Submission of Fabian and Donna McMorro

Development: Lissinagroagh Wind Farm

Applicant: FuturEnergy Ireland

Case Reference: PAX12.324290

Figure 1.1 Drainage Layout Plan 1 of 6 (Drawing No. 10955-2051), Note Green interceptor drain and Cairn AH01 we have highlighted in Yellow.

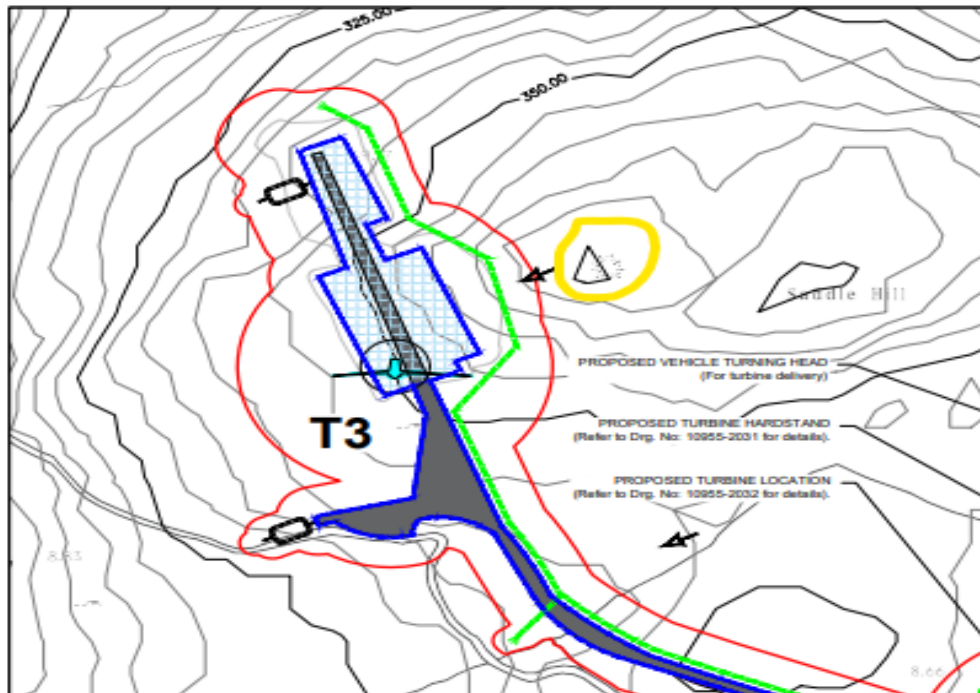
Having examined **Drainage Layout Plan 1 of 6 (Drawing No. 10955-2051)**, we note that a proposed interceptor drain is located between AH01 and Turbine T3. Based on approximate measurements taken from this drawing, the interceptor drain appears to pass within approximately **50–60 metres** of the archaeological monument. As the drawing contains no dimensioned offsets or separation distances, this measurement cannot be independently verified and could only be confirmed by the applicant.

Figure 1.1 below reproduces **Drainage Layout Plan 1 of 6 (Drawing No. 10955-2051)**. The proposed interceptor drain has been highlighted in **green**, while the location of archaeological monument **AH01 (LE008-006001 & LE008-006002)** has been highlighted in **yellow**. This figure illustrates the proximity of the proposed drainage works to the archaeological complex and highlights the absence of dimensioned separation distances within the applicant's submitted drawings.

In our view, the application should have clearly identified and dimensioned the relationship between AH01 and all elements of the proposed development, including turbine foundations, hardstands, crane pads, cable trenches, interceptor drains and any other associated excavation works. Without this information, it is not possible for the Board or members of the public to properly assess the potential impacts of the proposed development on this protected archaeological site.

Figure 3.2 Figure 9 (Landslide Susceptibility Map) contained within Appendix 7-1 – Peat Stability Risk Assessment. Note our home marked with red dot.

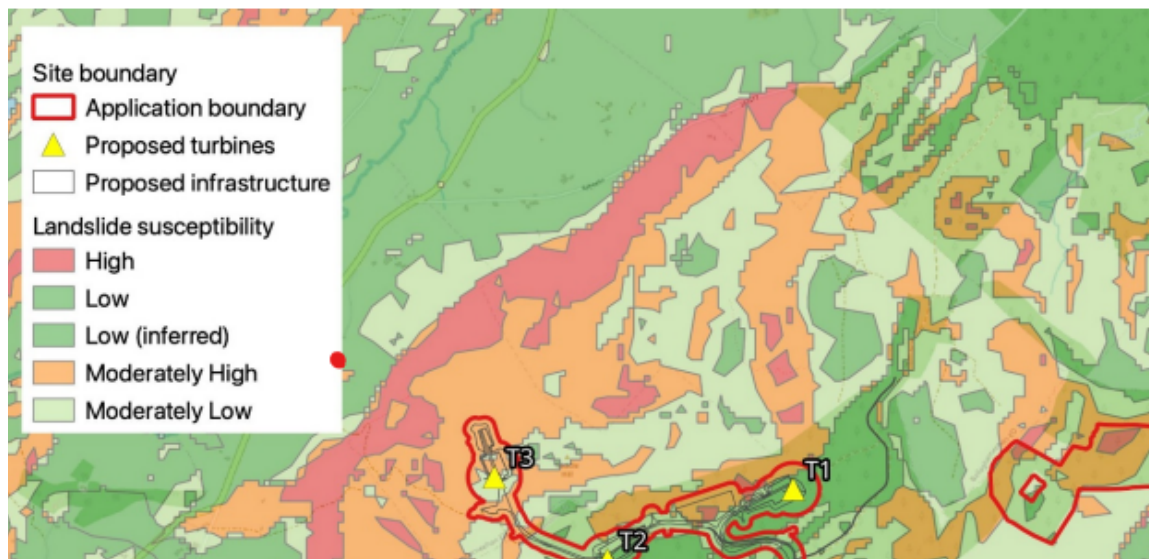
Figure 9 (*Landslide Susceptibility Map*) contained within **Appendix 7-1 – Peat Stability Risk Assessment** identifies an area of **high landslide susceptibility** on the western slopes of Saddle Hill.

The applicant's own assessment therefore recognises that parts of Saddle Hill are susceptible to landslide occurrence. This is particularly relevant given the extensive excavation proposed for turbine foundations, crane hardstands, access tracks, cable trenches, drainage works and associated earthworks within the same hillside environment.

While the EIAR concludes that the overall peat stability risk is acceptable, it is not clear whether this conclusion has been reached using a complete and accurate understanding of the geological and hydrogeological conditions on Saddle Hill.
